Remarks

Figure 1 has been amended as follows:

FIG. 1

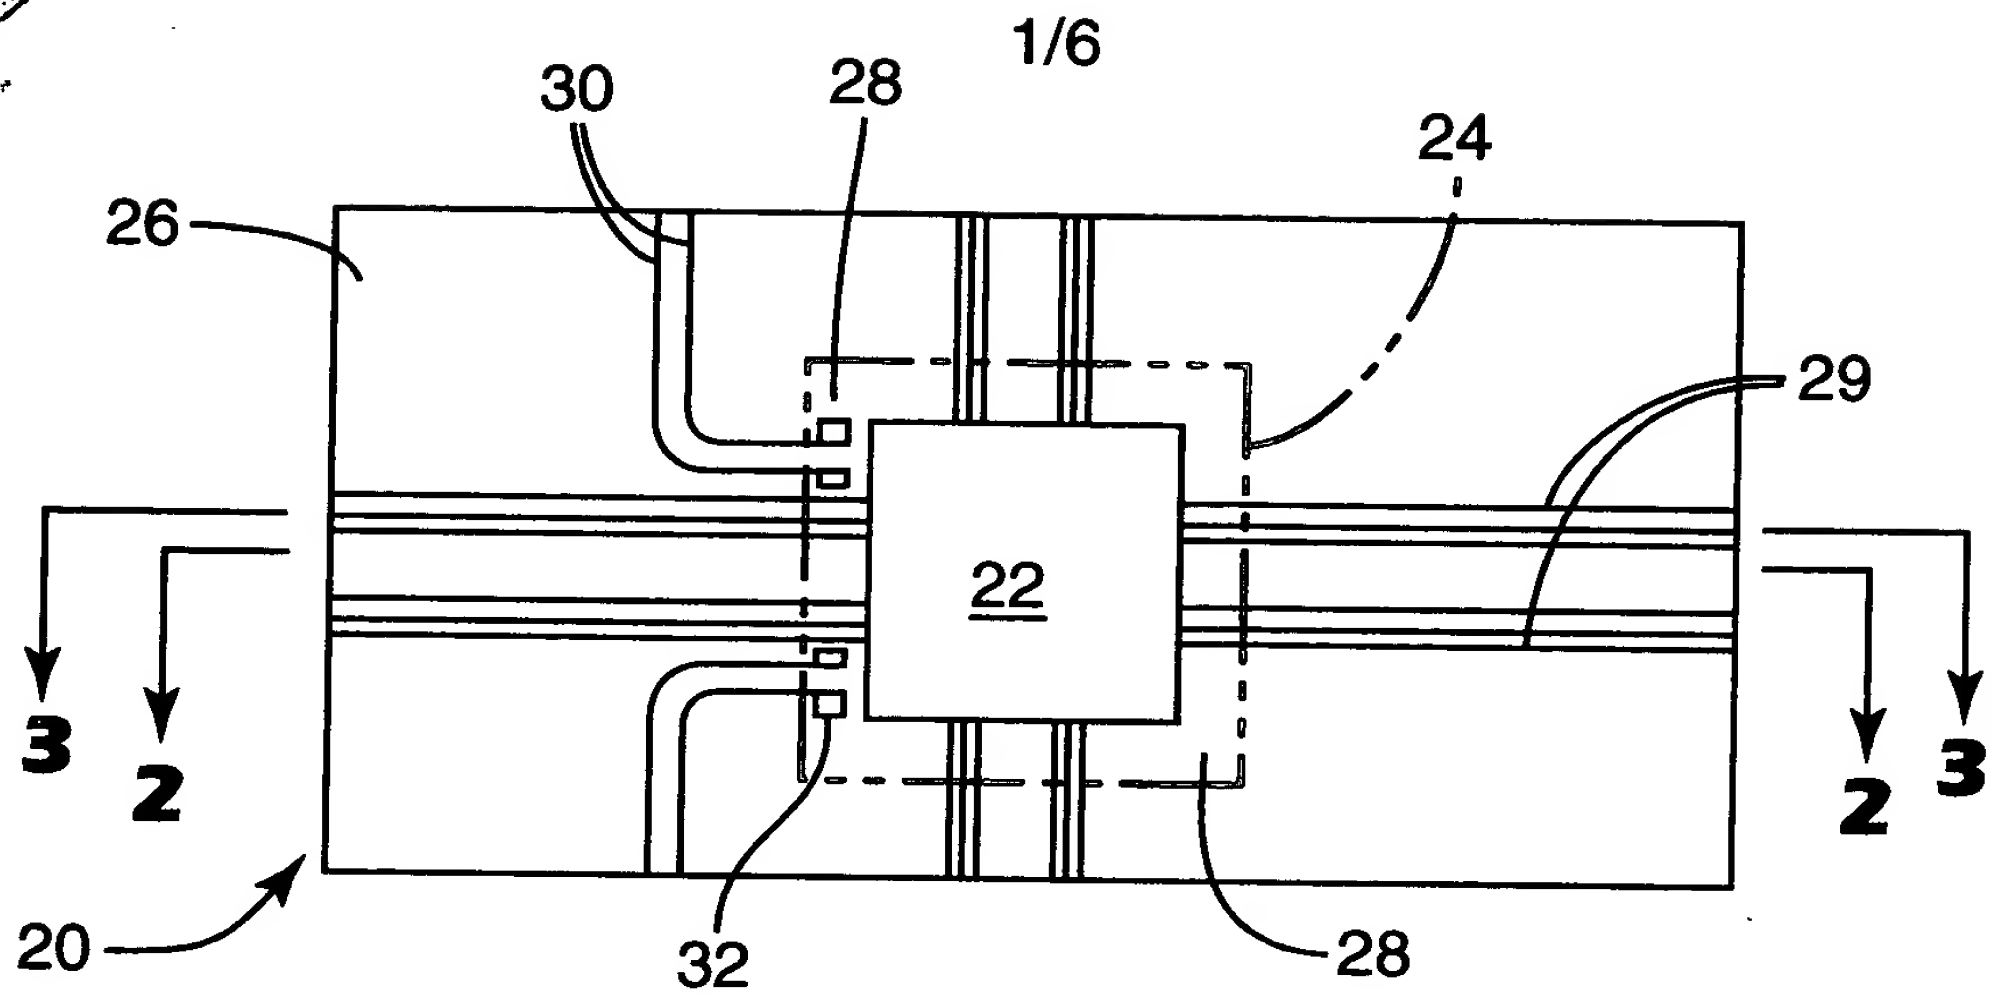
The line format of the die (24) has been changed to "phantom." Support for this amendment is found on page 7, lines 6-7.

FIG. 2

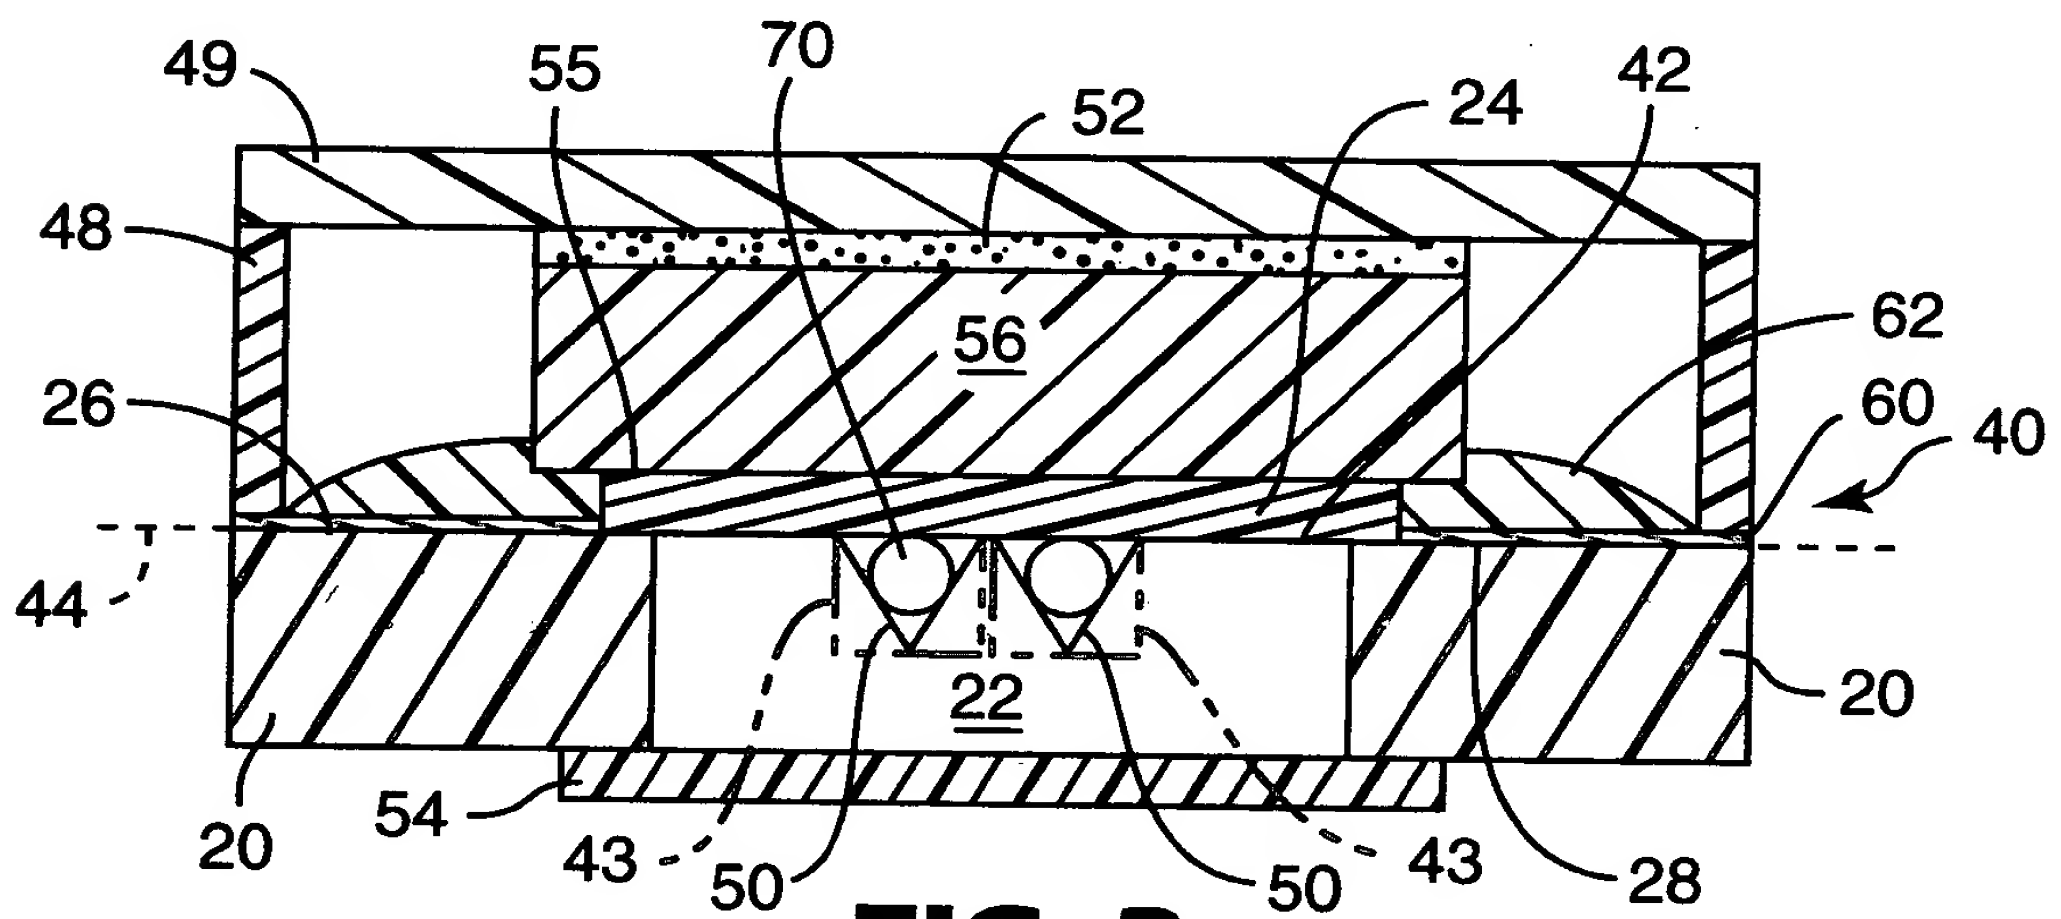
The cross-hatching of the package frame (20) has been changed to indicate an insulative part. Support for this amendment is found at page 7, line 24 - page 8, line 12.

The cross-hatching has been removed from the aperture (22). Support for this amendment is found at page 10, lines 20-25.

The line format for optical micro-mechanical devices (43) has been changed to "phantom." Support for this amendment is found at page 8, lines 20-21.

The cross-hatching for the flex circuit (60) has been changed to indicate a conductive material. Support for this amendment is found at page 9, lines 15-21.

The cross-hatching has been removed from the lenses (70) shown in end-view. Support for this amendment is found at page 2, lines 27-31.

FIG. 3

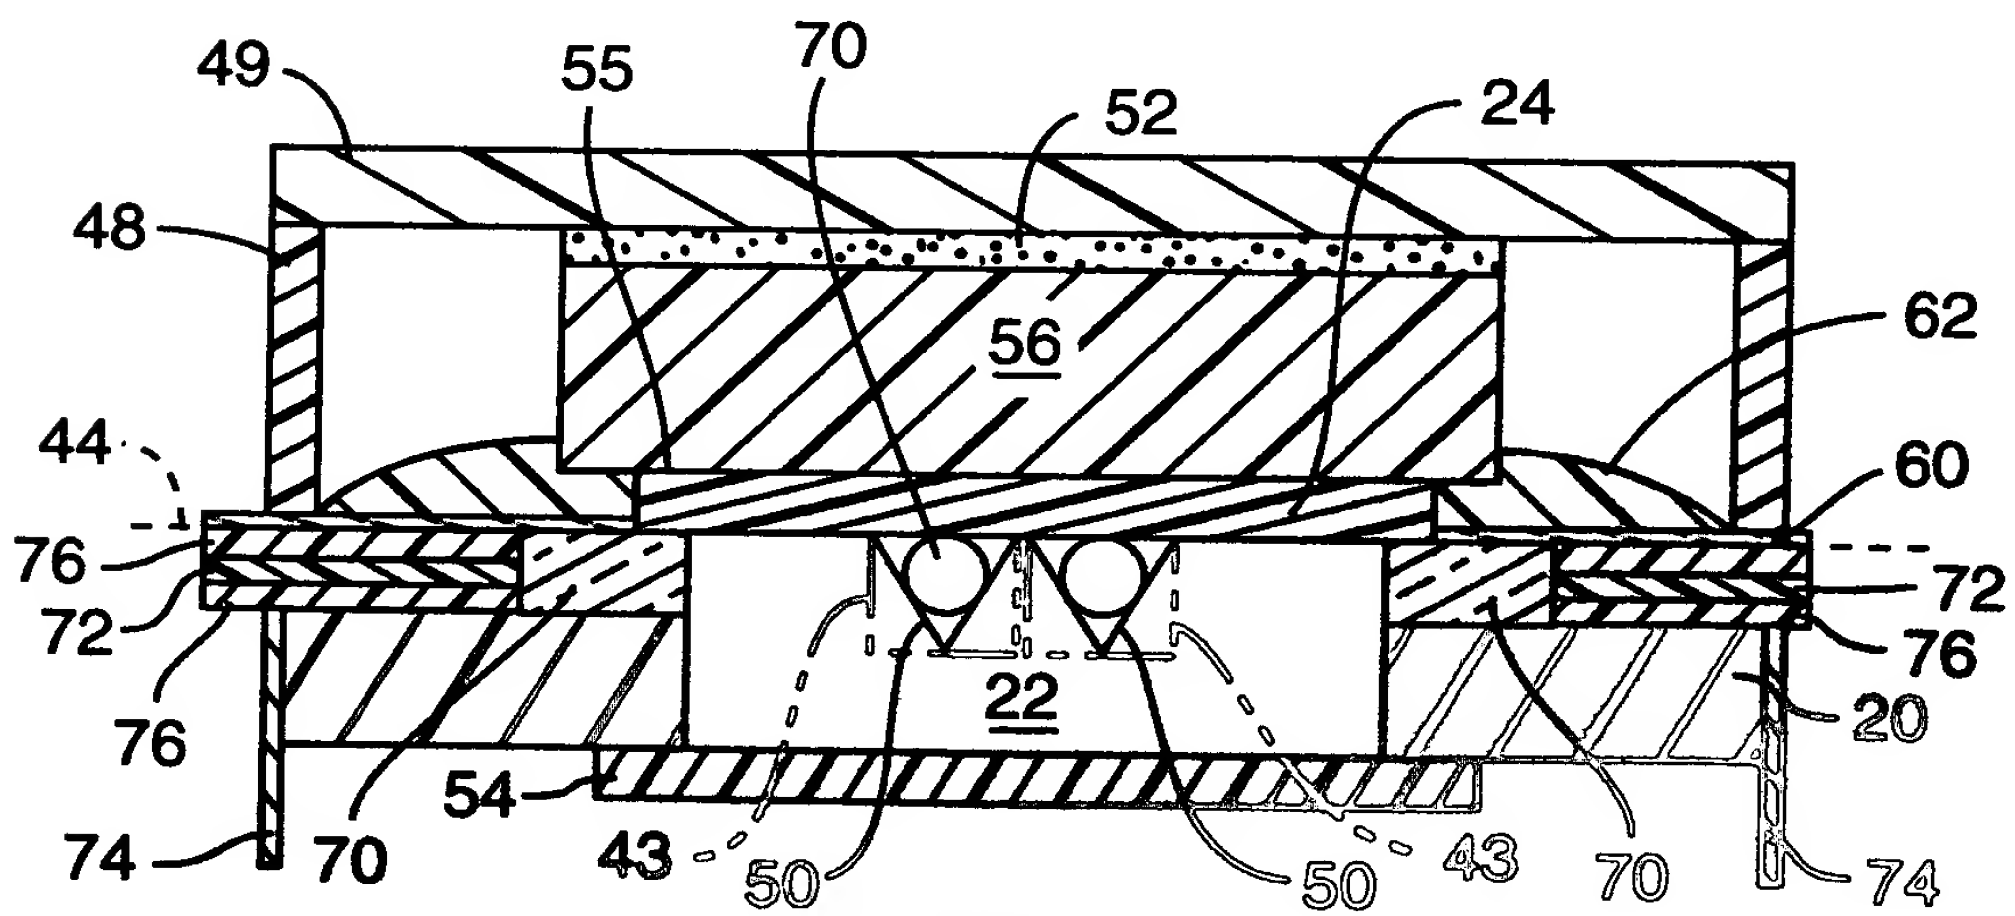
The cross-hatching of the package frame (20) has been changed to indicate an insulative part. Support for this amendment is found at page 7, line 24 - page 8, line 12.

The cross-hatching has been removed from the aperture (22). Support for this amendment is found at page 10, lines 20-25.

The line format for optical micro-mechanical devices (43) has been changed to "phantom." Support for this amendment is found at page 8, lines 20-21.

The cross-hatching for the flex circuit (60) has been changed to indicate a conductive material. Support for this amendment is found at page 9, lines 15-21.

The cross-hatching has been removed from the lenses (70) shown in end-view. Support for this amendment is found at page 2, lines 27-31.

FIG. 4

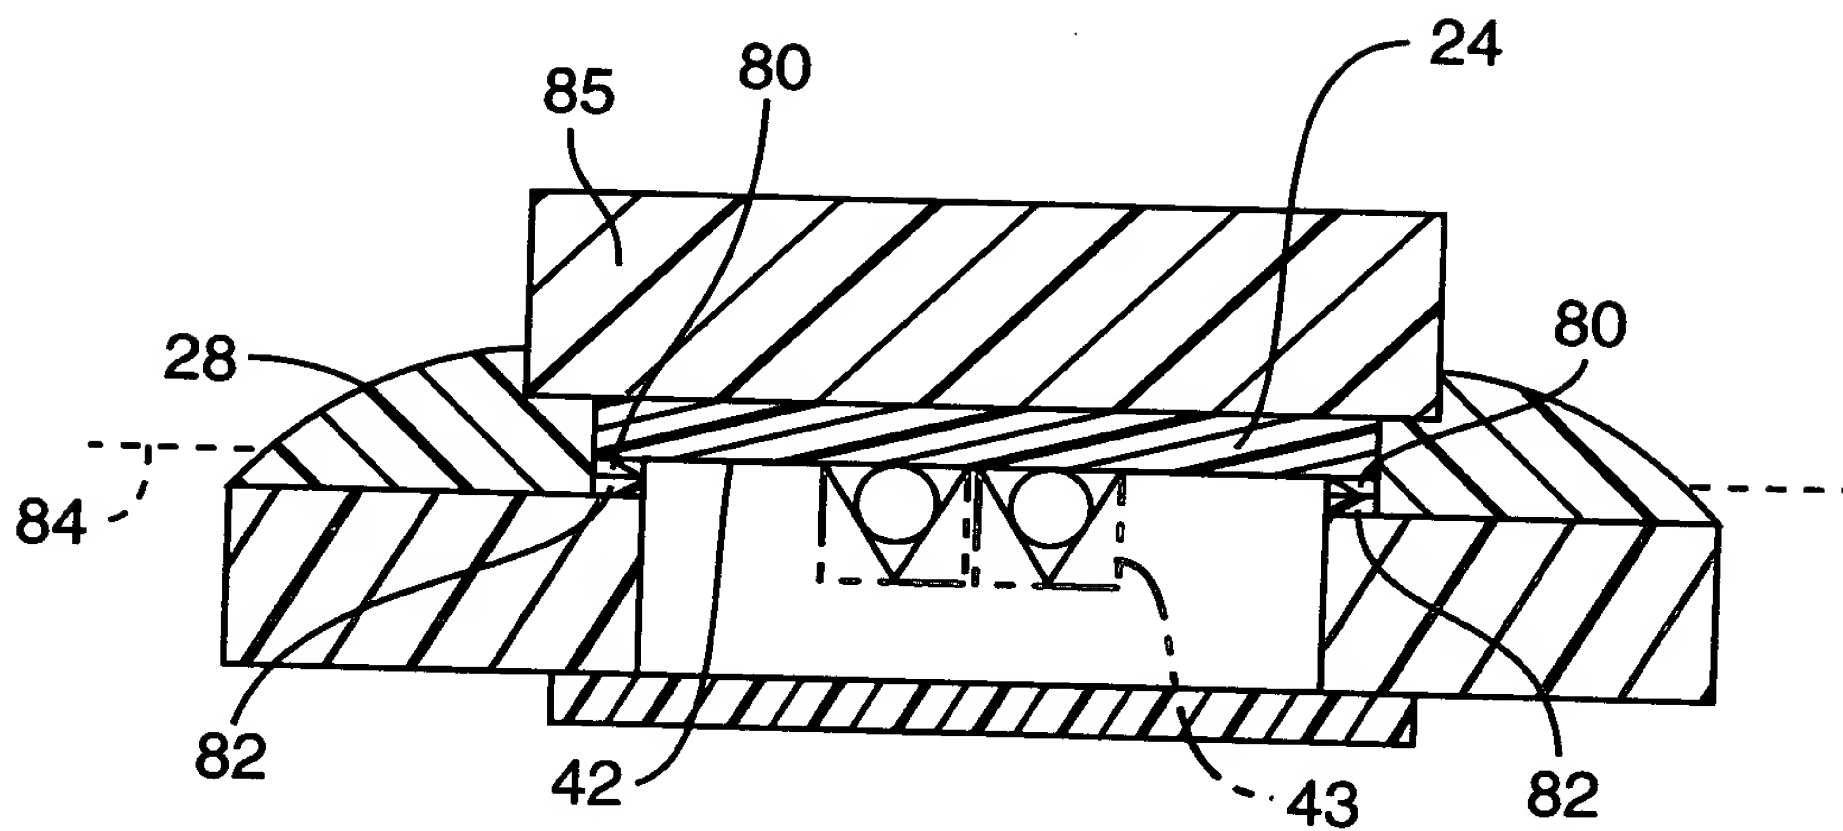
The cross-hatching of the package frame has been changed to indicate an insulative part. Support for this amendment is found at page 7, line 24 - page 8, line 12.

The cross-hatching has been removed from the aperture. Support for this amendment is found at page 10, lines 20-25.

The line format for optical micro-mechanical devices (43) has been changed to "phantom." Support for this amendment is found at page 8, lines 20-21.

The cross-hatching has been removed from the lenses shown in end-view. Support for this amendment is found at page 2, lines 27-31.

FIG. 5

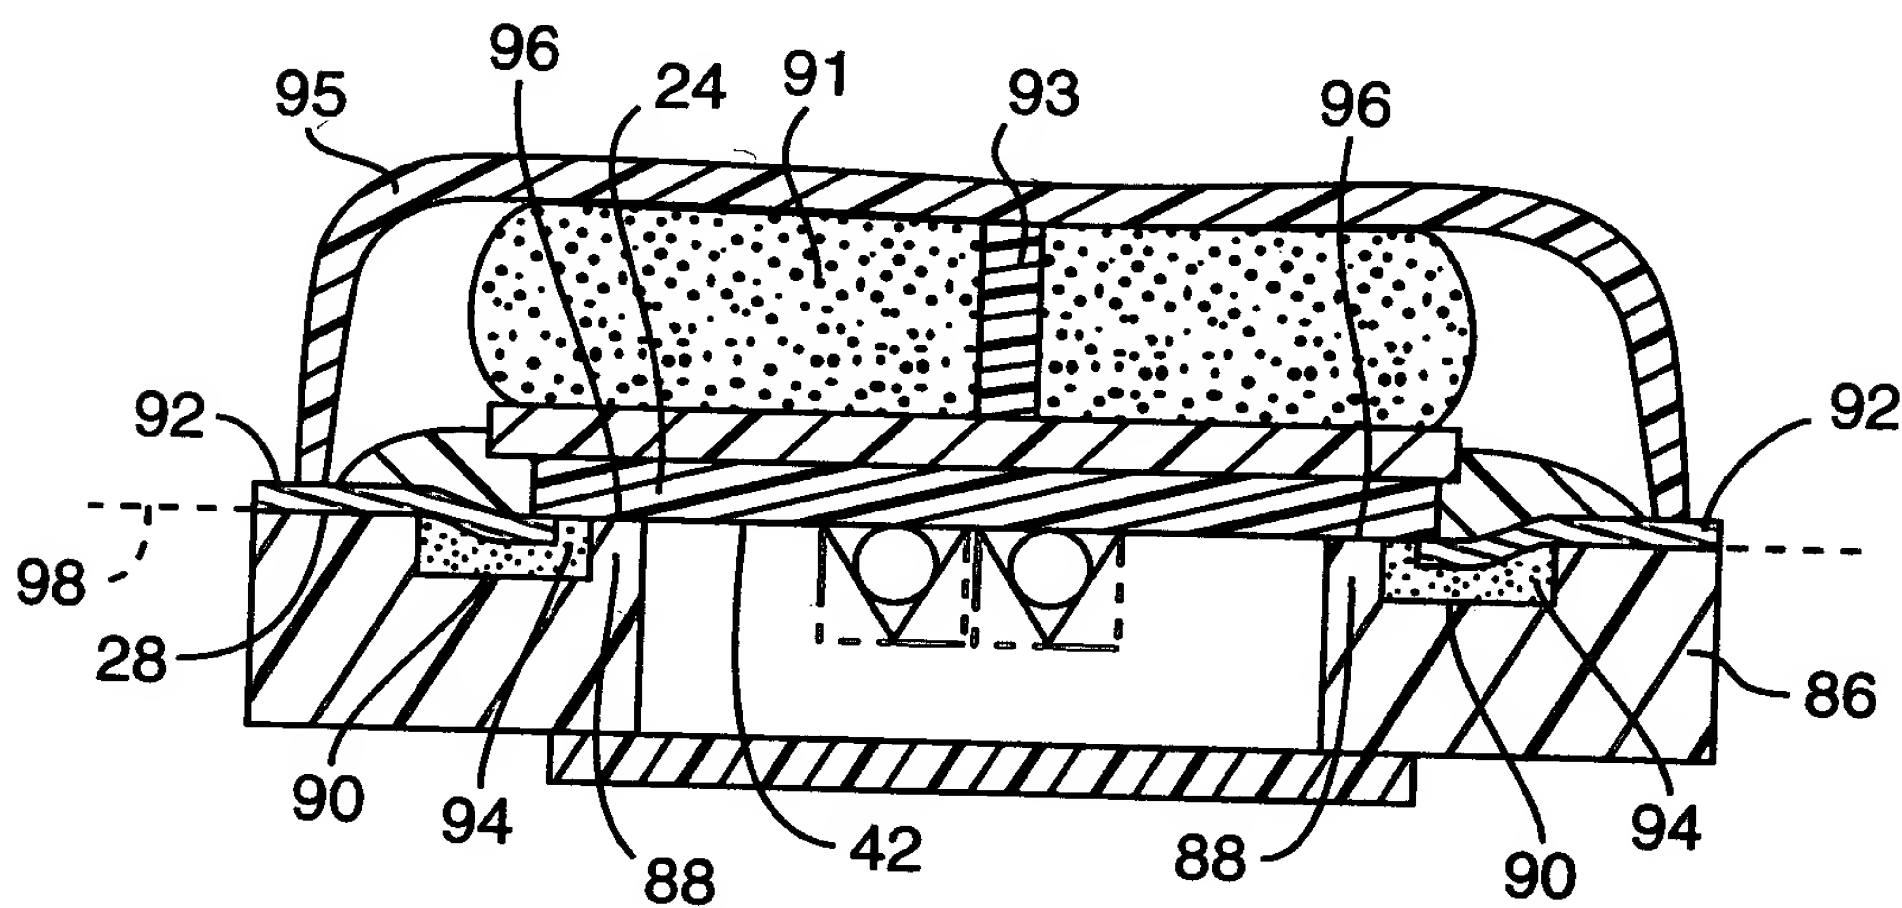
The cross-hatching of the package frame (86) has been changed to indicate an insulative part. Support for this amendment is found at page 7, line 24 - page 8, line 12.

The cross-hatching has been removed from the aperture. Support for this amendment is found at page 10, lines 20-25.

The line format for optical micro-mechanical devices has been changed to "phantom." Support for this amendment is found at page 8, lines 20-21.

The cross-hatching for the flex circuit (92) has been changed to indicate a conductive material. Support for this amendment is found at page 11, lines 30-32.

The cross-hatching has been removed from the lenses shown in end-view. Support for this amendment is found at page 2, lines 27-31.
